ADDENDUM NO #2 (Rev 10/2025)

ISSUE DATE: **October 29, 2025**

RE: **BABCOCK HALL CENTER FOR DAIRY RESEARCH PLANT UPGRADES**
University of Wisconsin – Madison
Madison, Wisconsin
MSN Project No. 0106-2330 / UWSA Project No. A-23-001

FROM: **Foth Productions Solutions**
2121 Innovation Court, Suite 100
De Pere, WI 54115

4 PR-202 – MECHANICAL PIPING 2ND FLOOR PARTIAL PLAN – CDR LAB 280

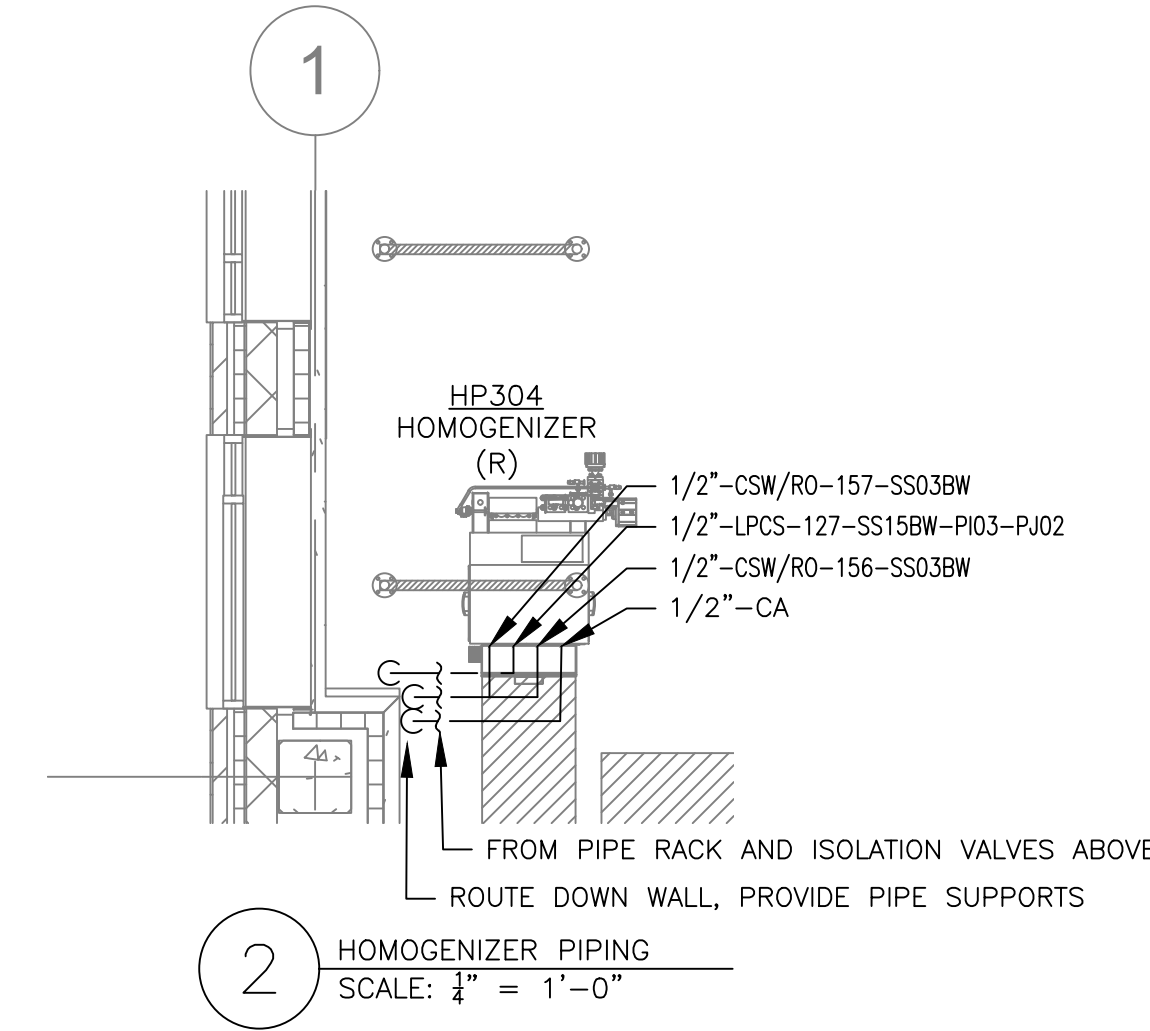
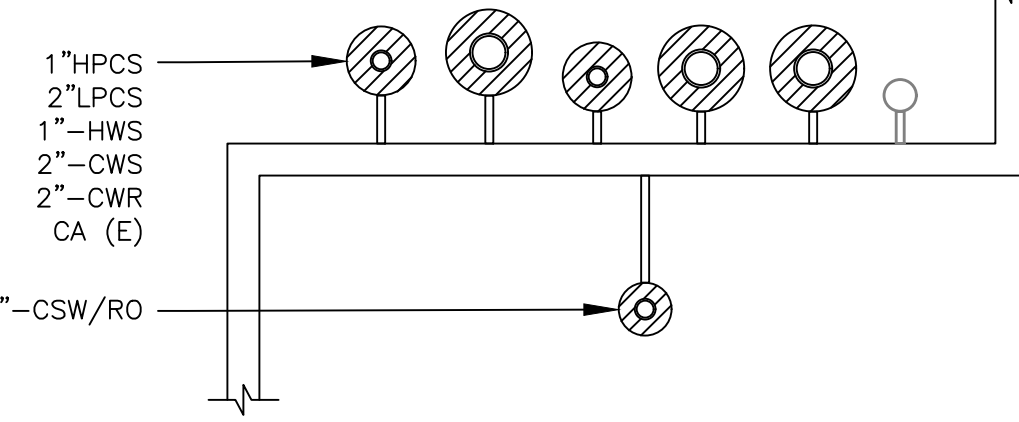
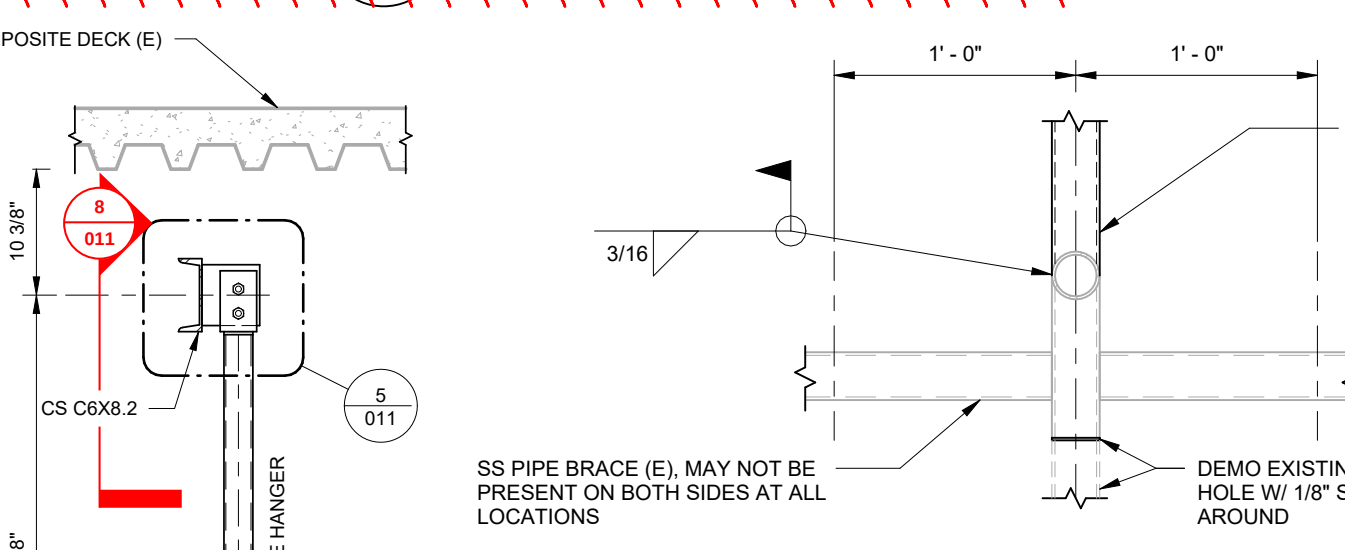
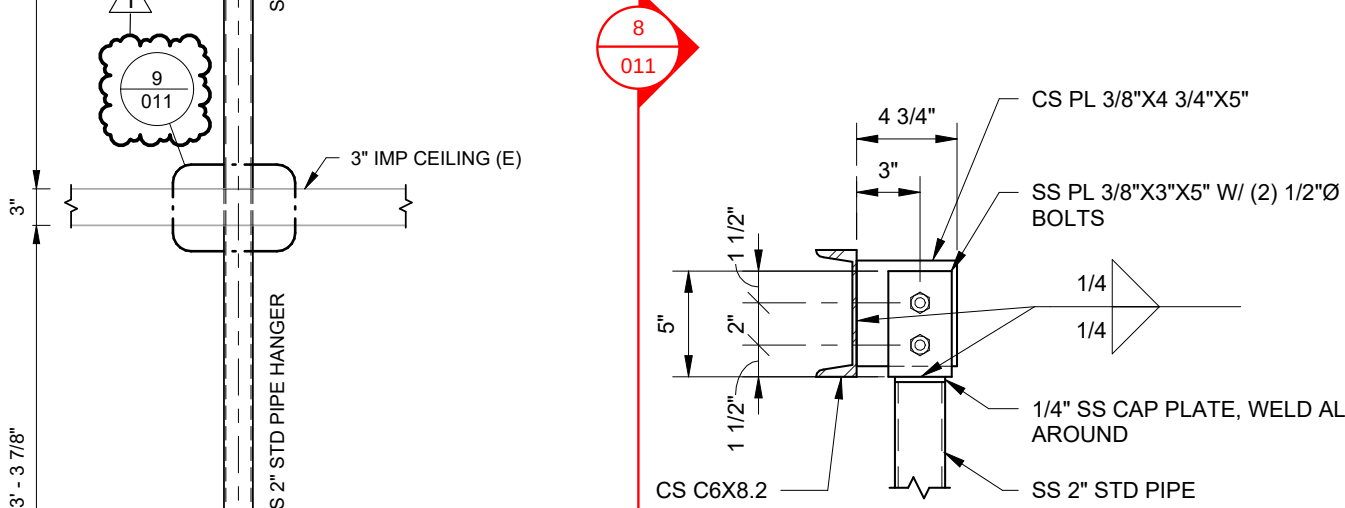
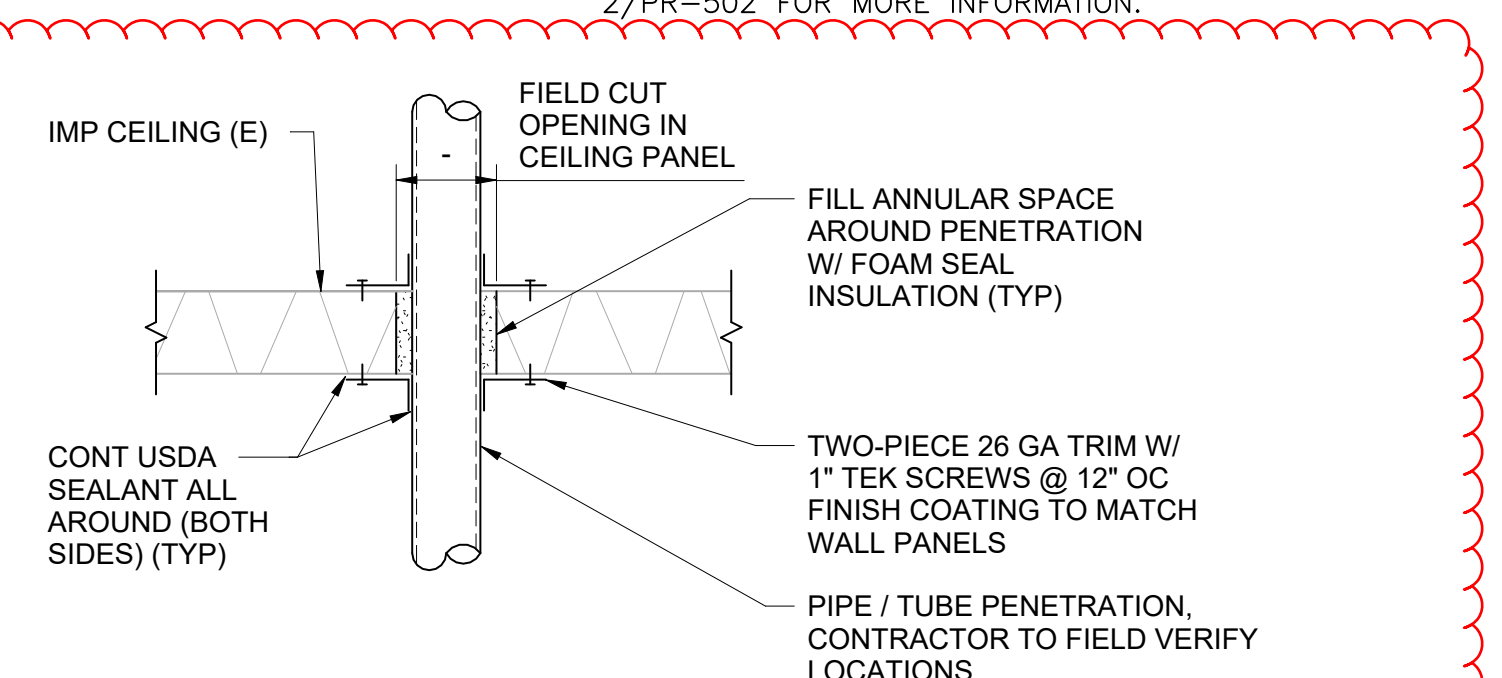
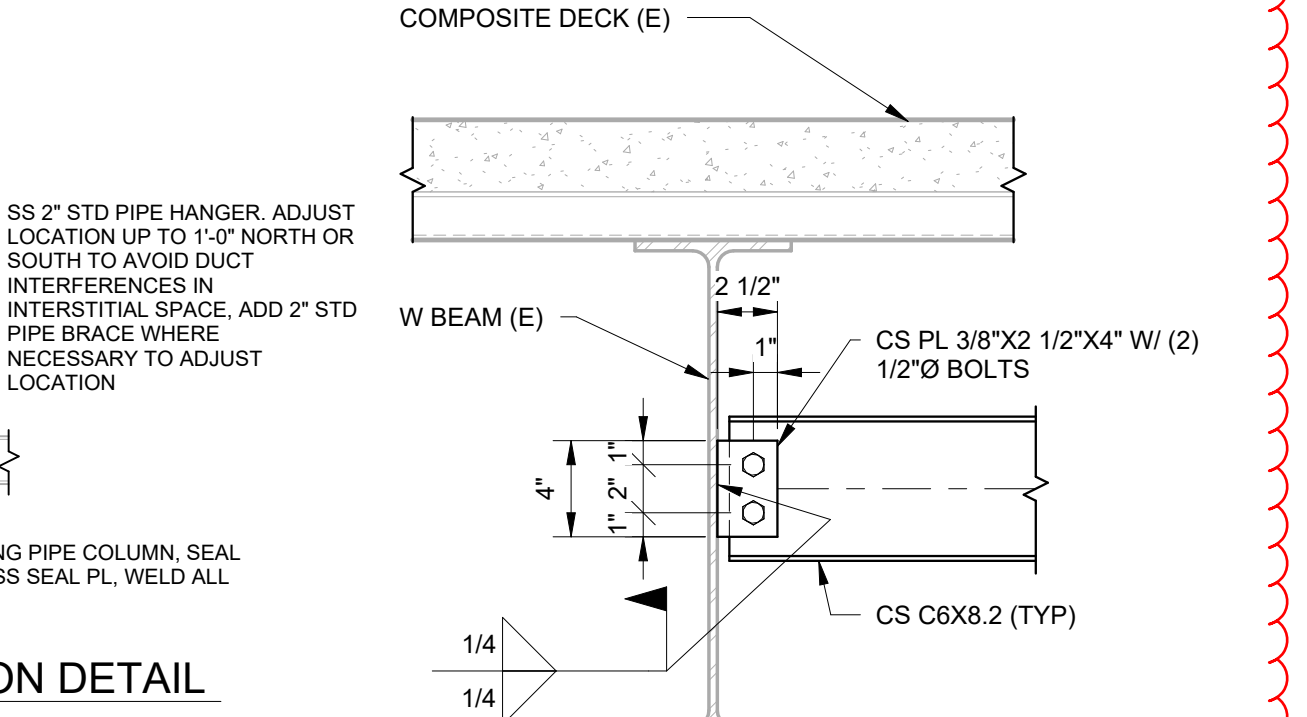
CONTRACTOR QUESTION: The demolition drawing (PR-202D) show that we are to remove the piping on the existing pipe supports but appears to show that the pipe supports are to be left in place. The installation drawing (PR-202) shows us reusing the pipe supports for the new piping and one of the pipe support legs appear to interfere with the Homogenizer.

a. Please indicate how you would like us to resolve this conflict.

b. Please indicate which contractor is responsible for the new pipe supports if needed as they are shared between the Plumbing and GPC scopes of work.

5 Added details for support leg that needs to be removed and associated mounting details in red.
6

RESPONSE: Only the support leg identified in red in attached updated drawing PR-202 is to be removed. Details for supporting the pipe rack from above are also included and clouded in red. This will be part of the GPC scope.

10 23U005-E-0012 – ELECTRICAL FEEDER ROUTING CDR PILOT PLANT UTILITIES ELECTRICAL
11 AND CONTROLS REFERENCE DRAWING

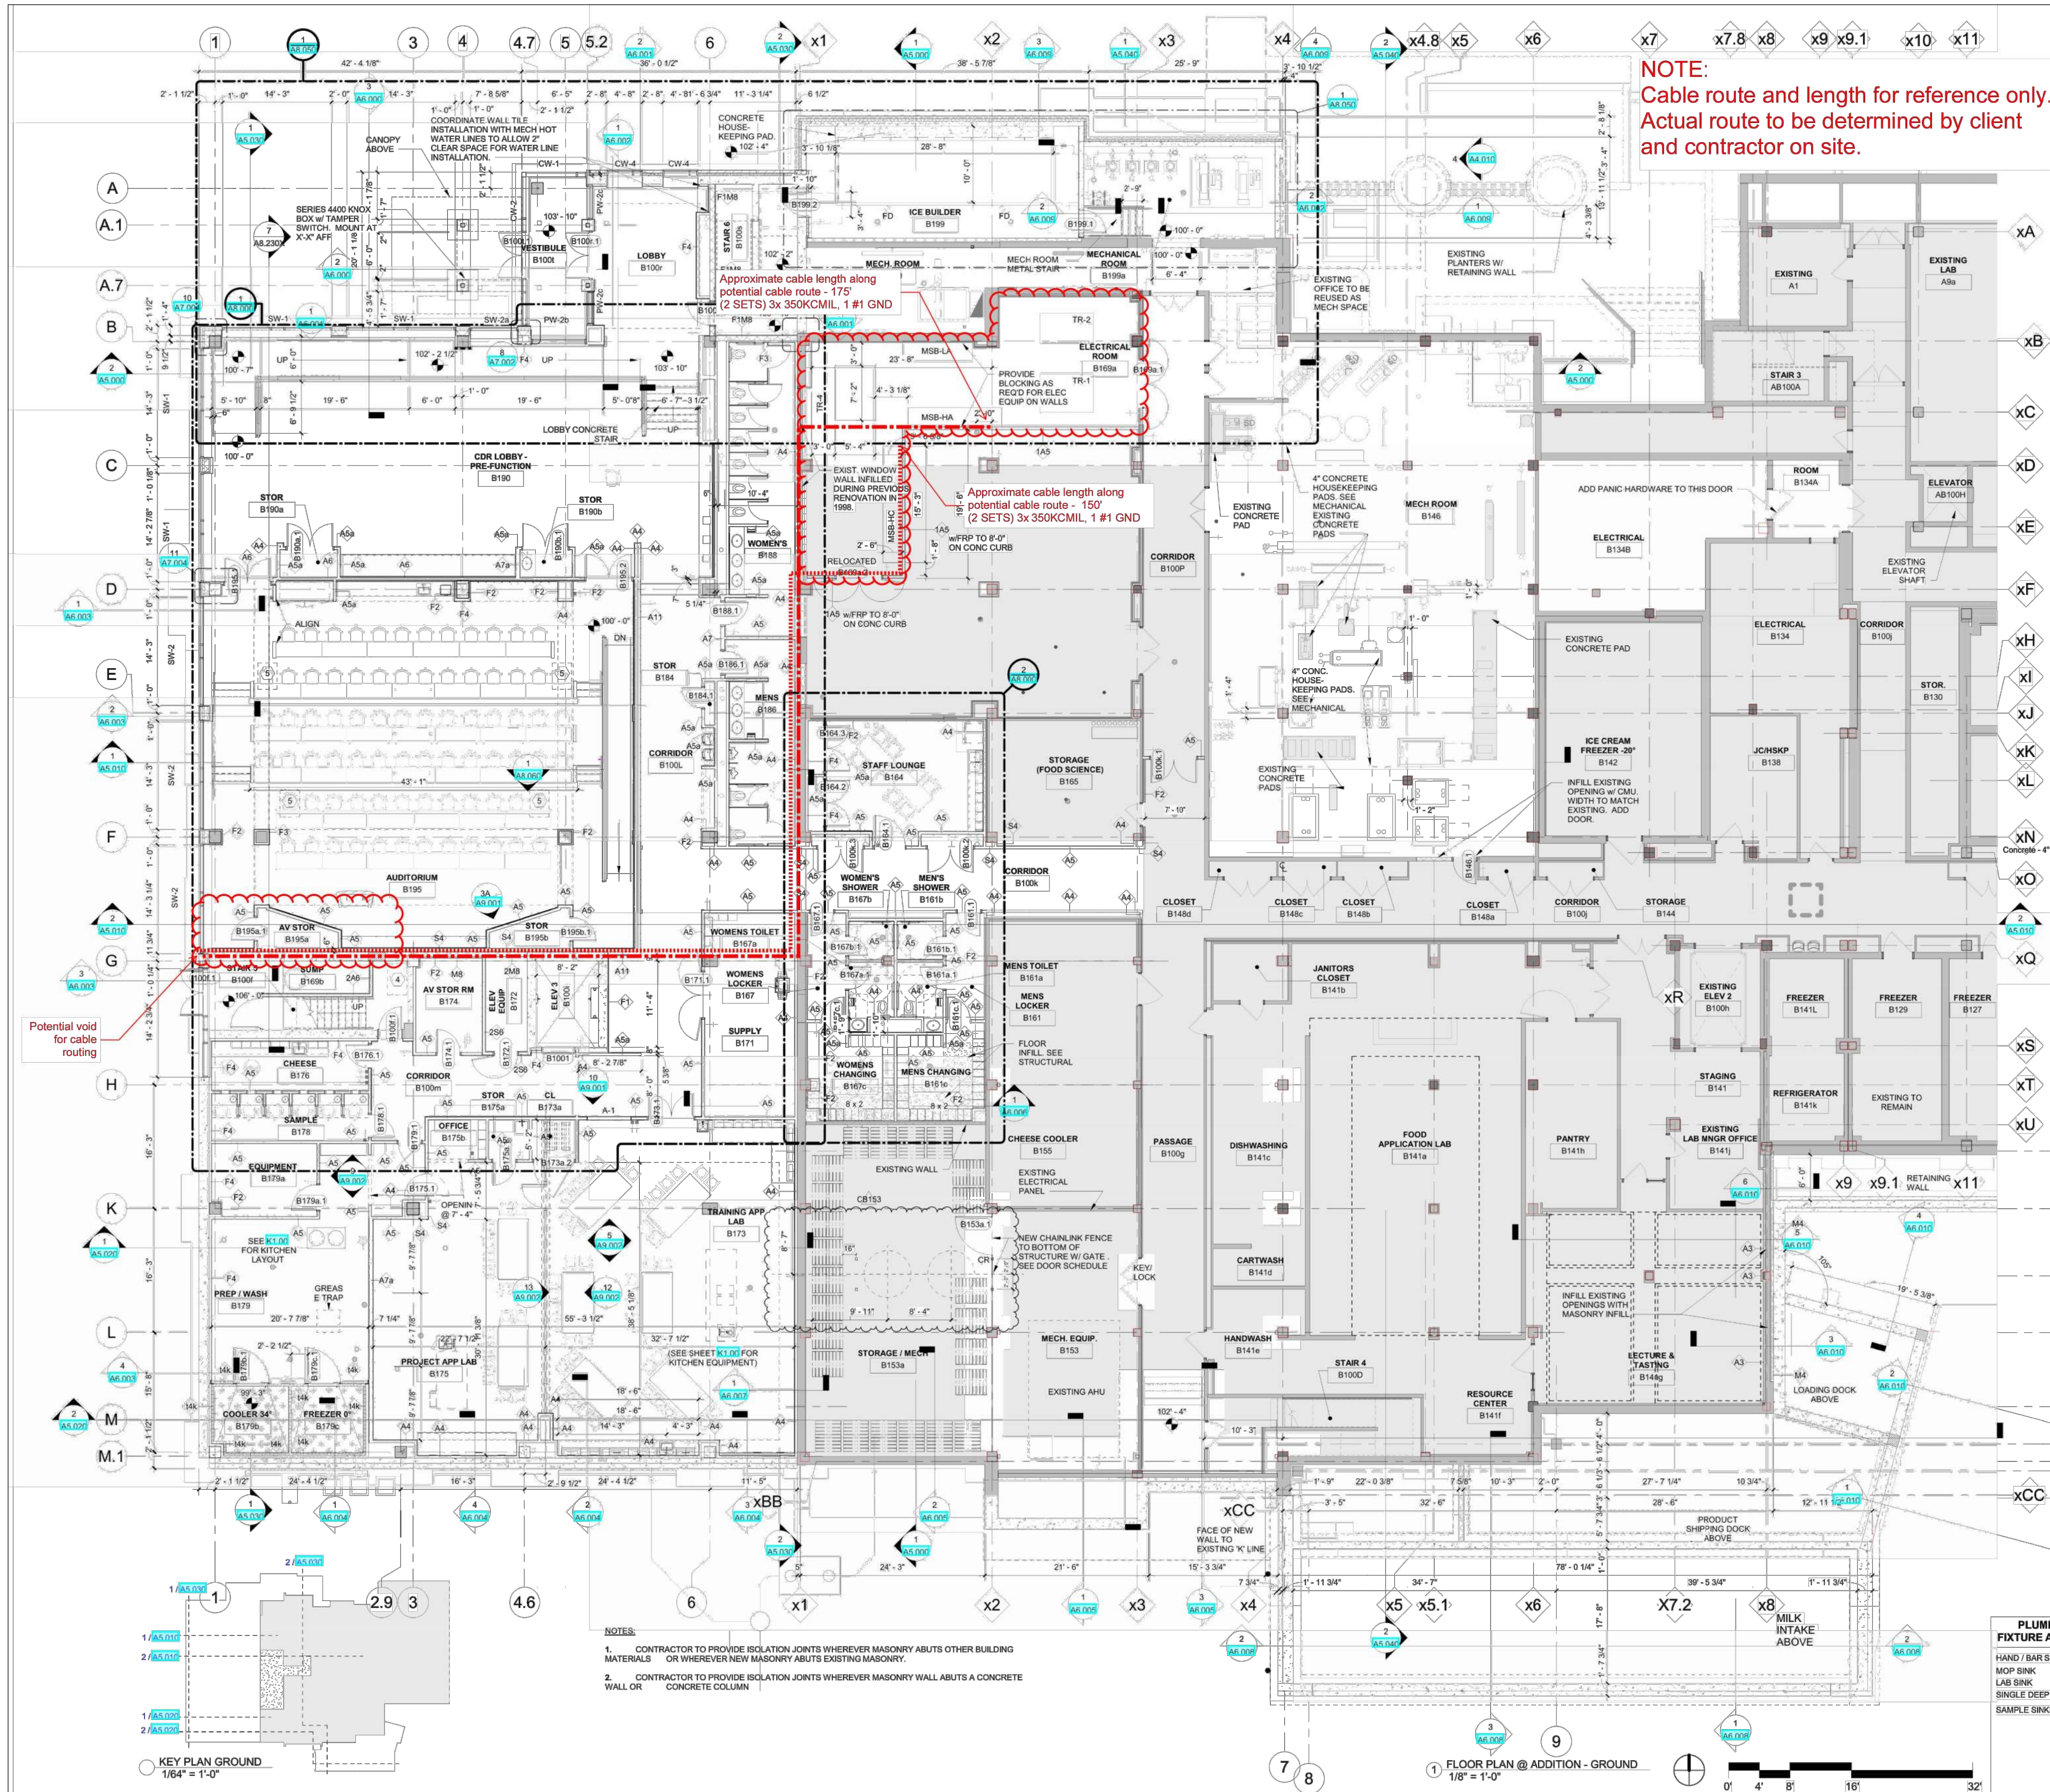
CONTRACTOR QUESTION: Without being able to see/ get into the electrical room for MSB/HA it was hard to get a measurable length for the feeder to PDP-480V. The plans do not show the basement or a route between the MSB/HA and panel PDP-480V. Is there a length/allowance that can be given for this feeder?

RESPONSE: See attached reference drawings 23U005-E-0012 through 23U005-E-0016 for proposed wire and cable routing and approximate lengths.

NOTE:
Cable route and length for reference only.
Actual route to be determined by client
and contractor on site.
